**Attachment 1 - Cadastral Plan  
DA 2014/31.3 - Lennox Rise**

**LENNOX RISE  
 MODIFIED ALLOTMENT LAYOUT  
 (DA2014/31.3)**

## Planning and Environmental Health Group Section 4.55 Modification Application Assessment Form

**LENNOX RISE  
 APZ AND LIMITATIONS PLAN**

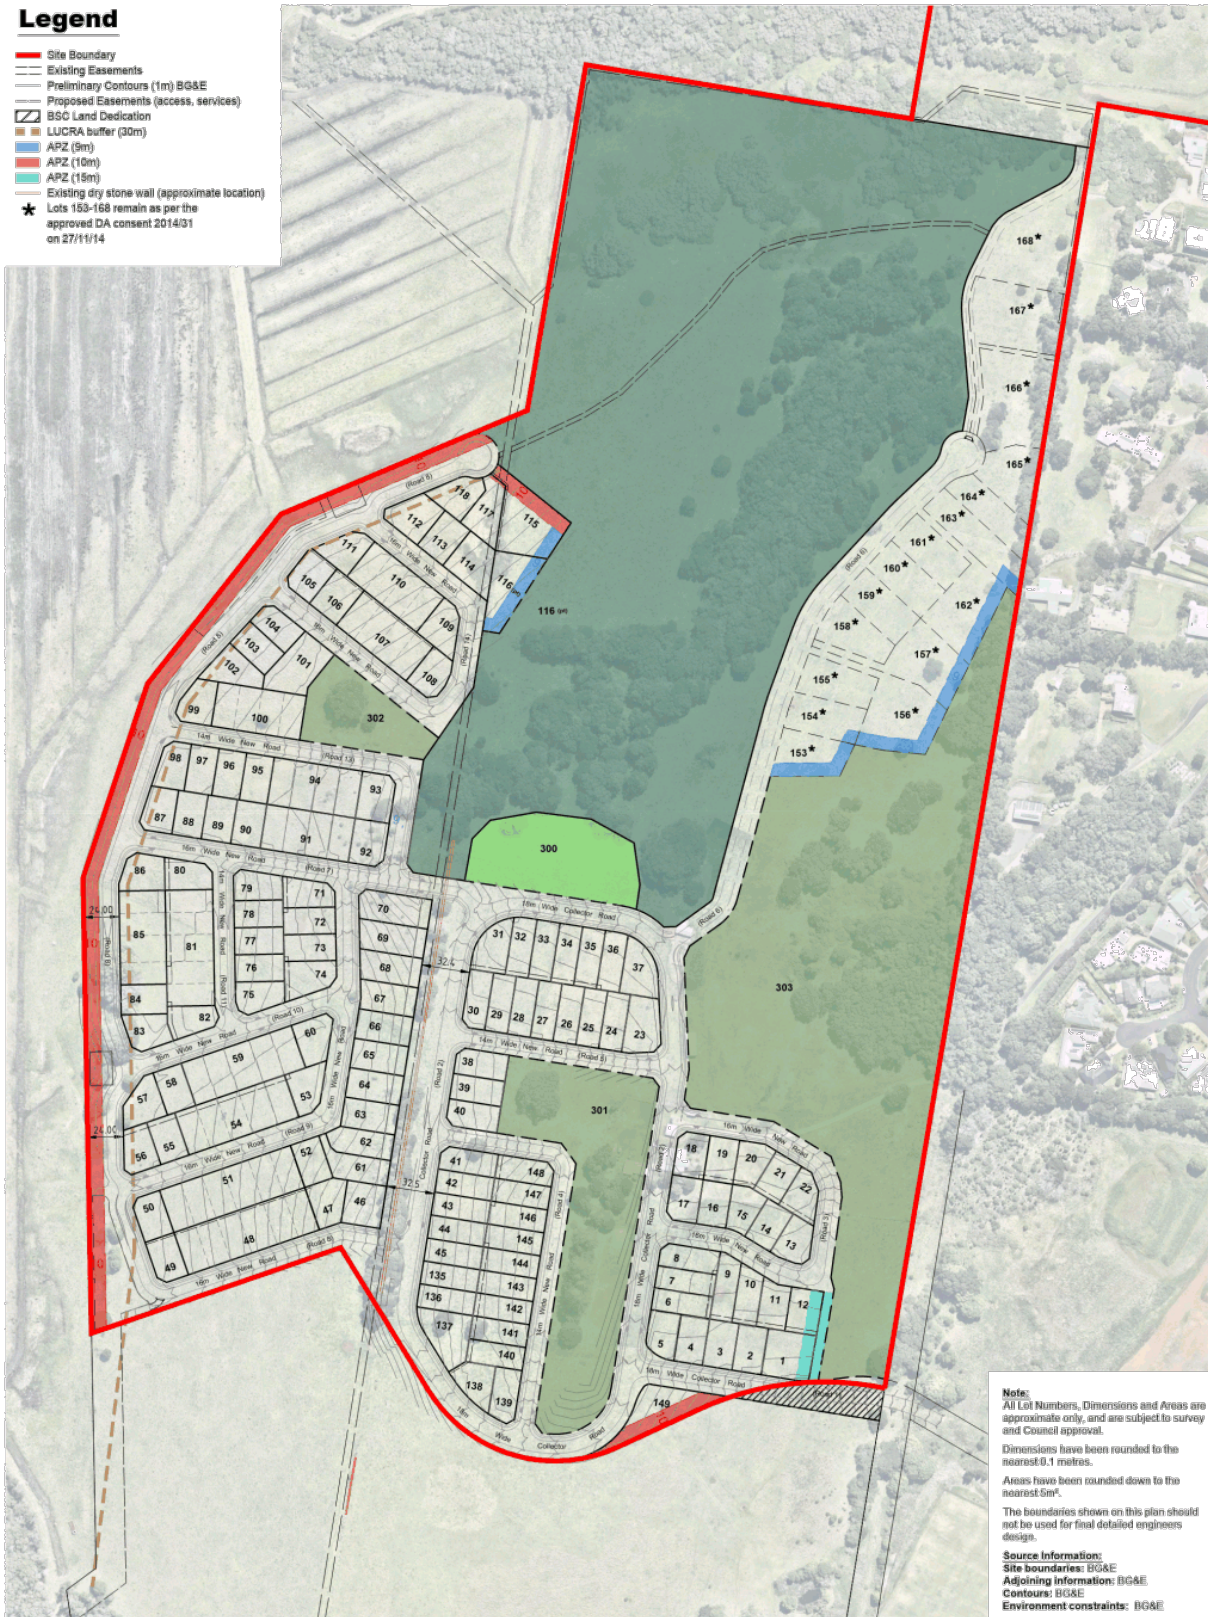
1. The development proposal is to comply with the subdivision layout identified on the drawing prepared by RPS titled 'APZ and Limitations Plan', numbered 142550-06F and dated 29th April, 2020.

3. At the issue of a subdivision certificate, and in perpetuity to ensure ongoing protection from the impact of bush fires, the western boundary as identified on the drawing titled 'APZ and Limitations Plan' prepared by RPS, numbered 142550-06F and dated 29th April, 2020 shall be managed as an inner protection area (IPA) for a

6. A restriction to the land use, pursuant to section 88B of the 'Conveyancing Act 1919' shall be placed upon proposed Lots 1, 12, 149, 115, 116, 117, 153, 156, 157, 162 & 163 restricting habitable buildings within the areas identified as APZs as indicated on the drawing titled 'APZ and Limitations Plan' prepared by RPS, numbered 142550-06F and dated 29th April, 2020.

**LENNOX RISE  
 Layout Improvement Plan**

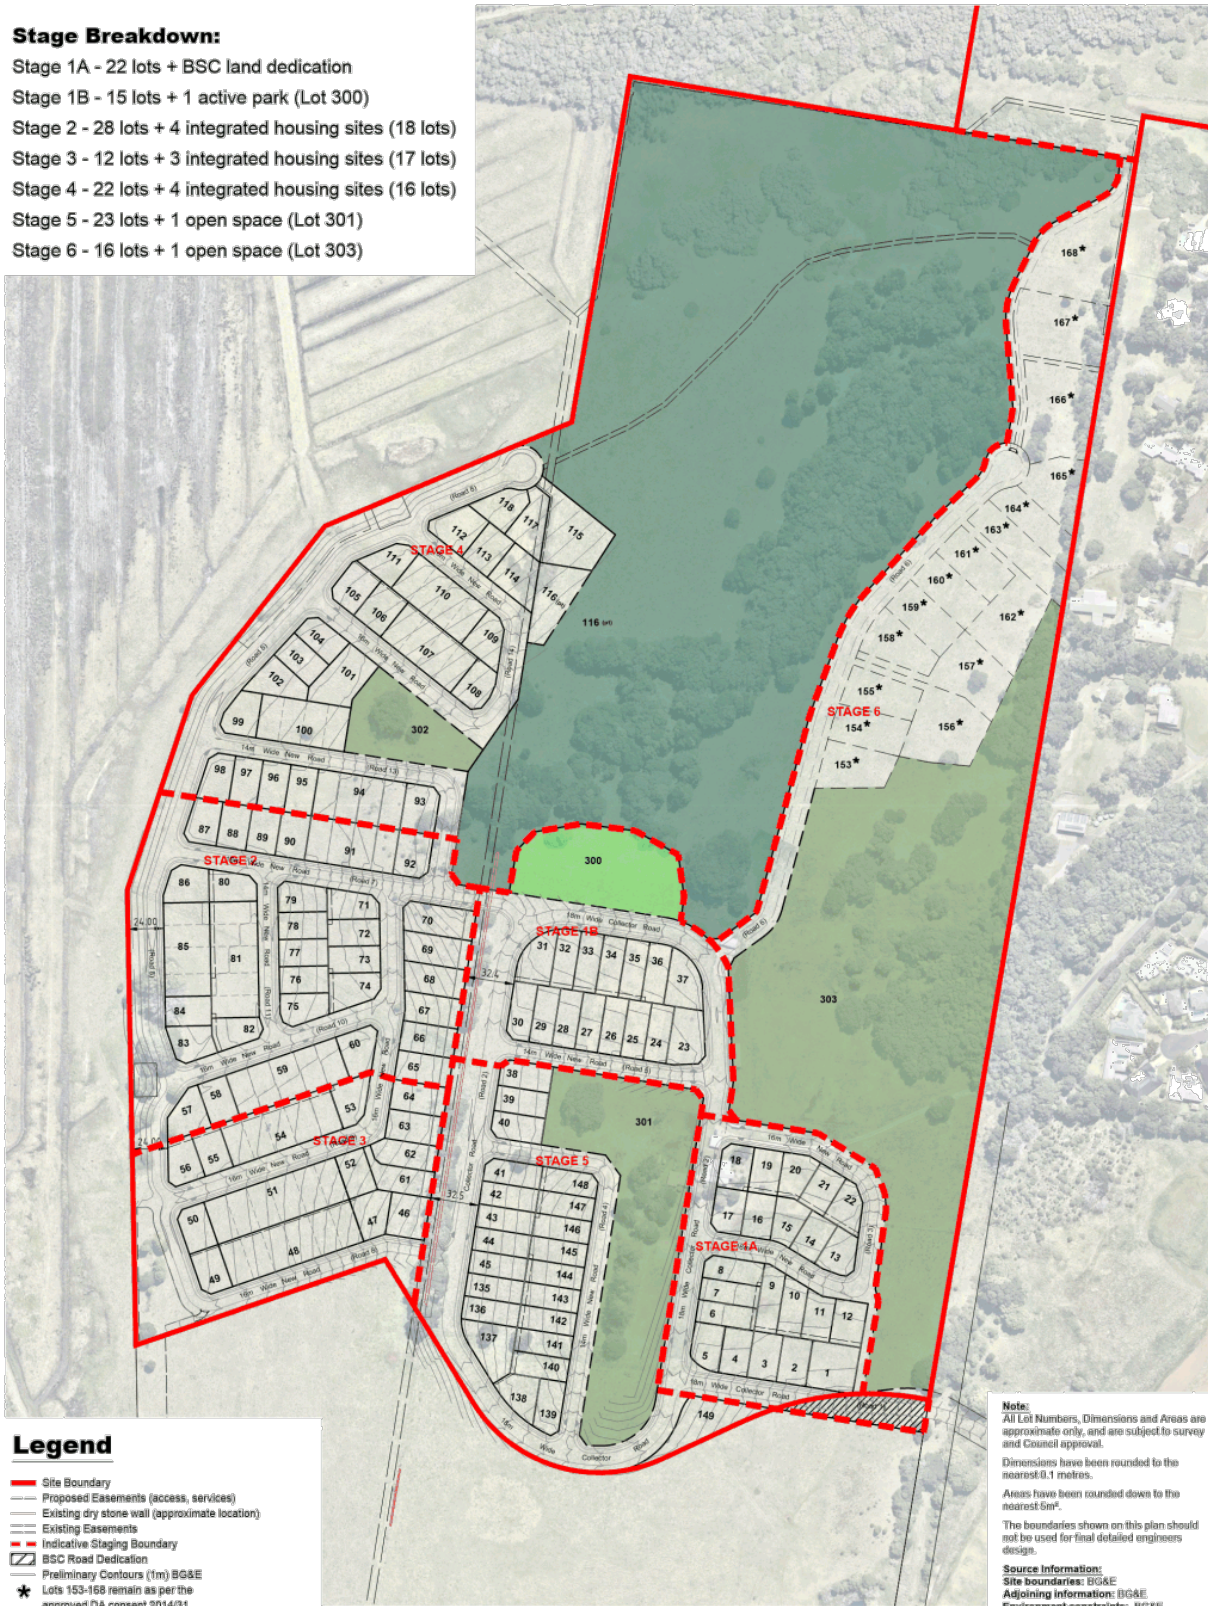
- Removal of all lots within LUCRA buffer to provide consistent perimeter road to adjoining land parcel
- Revised layout to avoid relocation of watermain
- Inclusion of house site for residual lot
- Removal of all lots within LUCRA buffer to provide consistent perimeter road to adjoining land parcel
- Increase of open space (Lot 302) to sufficiently cater for fig tree
- Removal of battle axe lots with long driveways
- Rotated block layout to address contours and provide permeable road network
- Conventional block depths, lot frontages and sizes for desired residential land use outcomes
- Lot orientation modified to reduce significant or piece meal retaining wall solutions
- Introduction of perimeter road for increased separation from undeveloped BSC landholding
- Dry stone wall and water main in the road reserve to provide for consistent management by BSC

- Reduction of Stage 2 'balance lots' on southern boundary
- Revised entry road alignment for improved road intersection, access to BSC landholding and visual amenity of open space on entry

Increase of open space (Lot 303) as a result of revised bus route meeting grade requirements

Increase of open space (Lot 301) to sufficiently cater for fig tree, avenue of trees and create a green link to BSC landholding

Introduction of perimeter road for increased separation from open space

FIGURE 2  
STORMWATER CATCHMENTS  
POST DEVELOPMENT

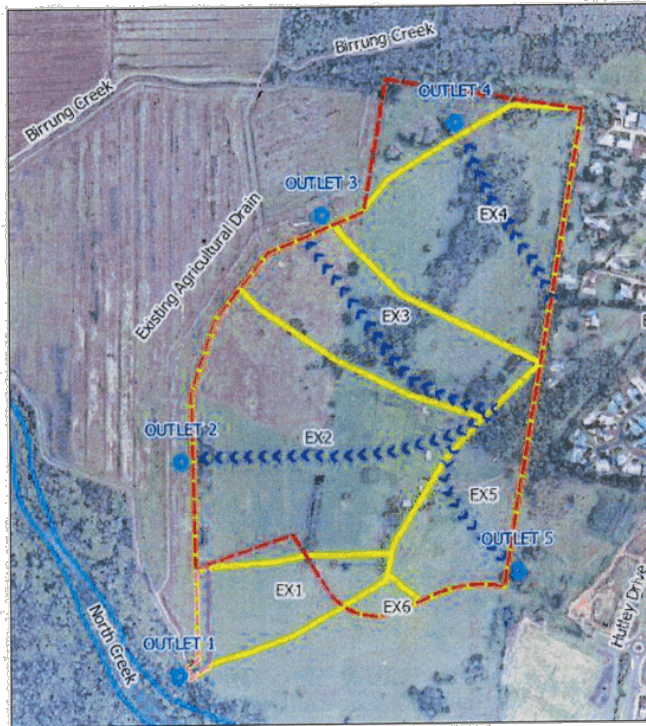
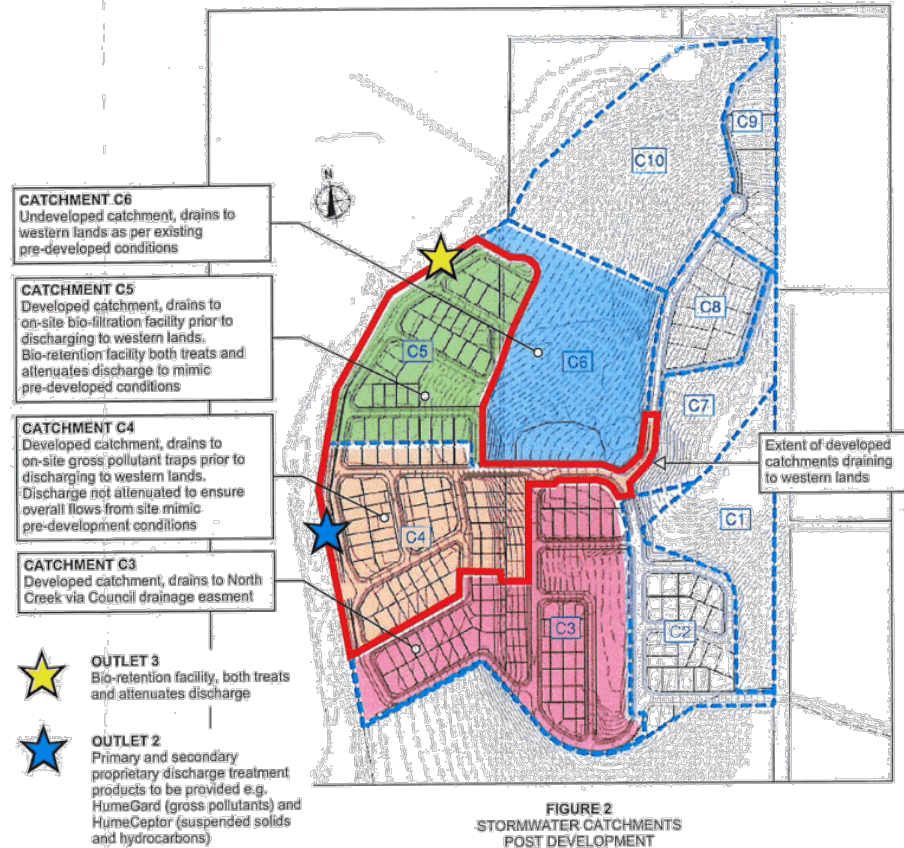
Since my correspondence of the 1<sup>st</sup> October, I've now received a map of the proposed 190 block subdivision's water drainage plan showing drainage outlets 1 to 4.

proposed in the earlier 2014 stormwater plan to outlets 1 and 4 was installed, it would significantly reduce the discharge from outlets 2 and 3.

As both North Creek and Birrung Creek are tidal, I suggest the bulk of the runoff should be directed into them and not through my private property as is being proposed.

I would have no objection to a drain from outlet 4 to Birrung Creek being constructed through my property at the developers expense.
